Hudson River Operable Unit 2 Sediment Remediation

Upland Site Preparation Work Plan

BASF Rensselaer
Rensselaer, New York

**BASF Manufacturing Plant, Site No 442027
Rensselaer Hudson River Operable Unit 02
Response to Comments**

DRAWING NUMBER:	C-102
SHEET NUMBER:	1 OF 1
REVISION	0

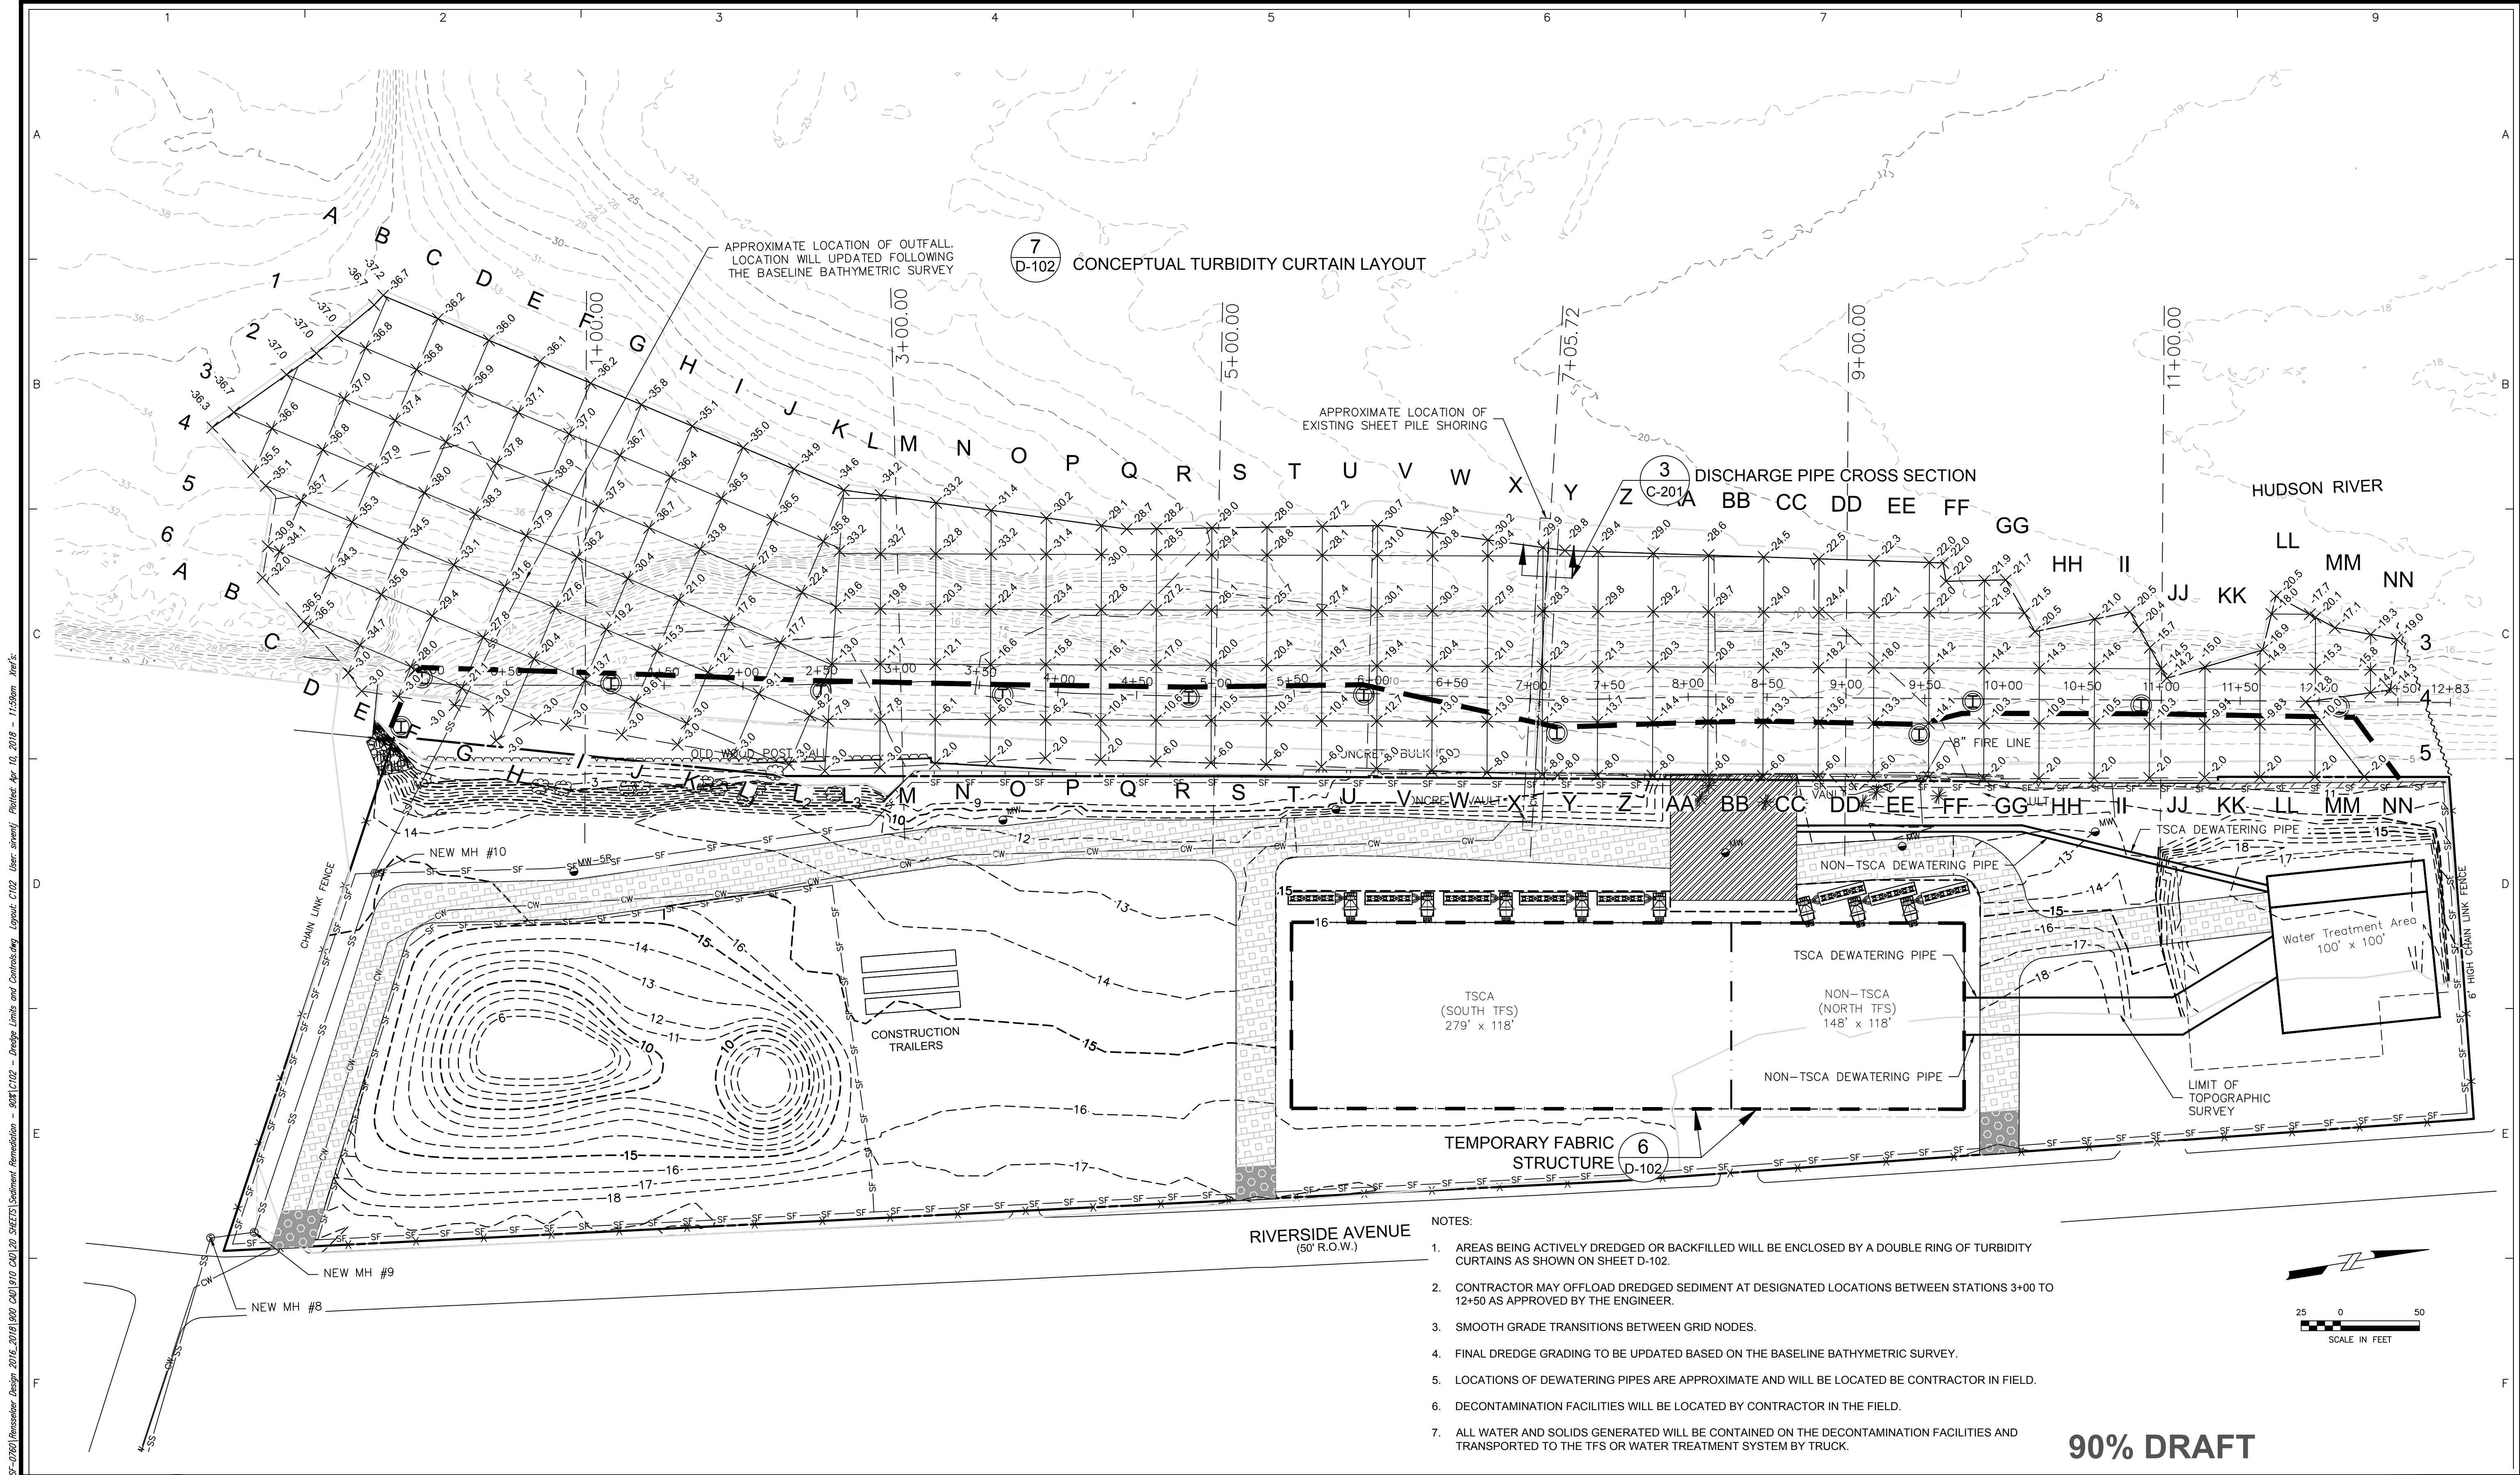
Comment 3: Section 2.0 Upland Site Preparation Activities. Due to the planned construction on the Site Layout (Drawing C-102) the BASF Performance Network Monitoring wells and piezometers need to be protected so they remain available for future monitoring. The monitoring points include LG-PZ-15R, LG-PZ-14R, LG-MW-SR, LG-PZ-6R, LG-MW-6R, LG-MW-2R, LG-PZ-10R, LG-MW-26 and LG-MW-25. Add a paragraph in this section detailing how the monitoring points will be protected.

- a. Unit operations of the water treatment plant, if known, should be described in the work plan and depicted on drawing number C-102.

- b. The work plan should describe how any contaminated or non-contaminated water treatment-generated solids from settling tank cleanout operations will be handled. If there will be any separate storage/handling areas, these should be described and depicted on drawing number C-102.

Comment 6: Appendix A Drawing C-102

- a. The drawing should include a depiction of the pipe routes, including those from the dewatering area, the sediment offloading area, and from the water treatment plant to the discharge location in the Hudson River (any discharge back to the river will require SPDES equivalent discharge limits and monitoring of the effluent.)

- b. The work plan indicates that the water treatment plant will be located on the old building foundation, but only the foundation (and not the treatment plant) is depicted on drawing number C-102. Show on the drawing the location of the water treatment plant.

- c. If there will be a decontamination pad/area, it should be depicted on the drawing and described in the work plan. Any drains/sumps for a decontamination area should be described along with a statement as to where the drainage water will be pumped. Pipe routes should be depicted on the drawing.

Response 3: A discussion of measures to protect the monitoring well has been added to the document.

Response 4a: A discussion of the water treatment components has been added to the document.

Response 4b: A discussion of measure to manage the solids has been added to the document.

Response 6a: The Drawing has been updated.

Response 6b The Drawing has been updated.

Response 6c: The Contractor will determine the final location of decontamination facilities. A note has been added to the Drawing.
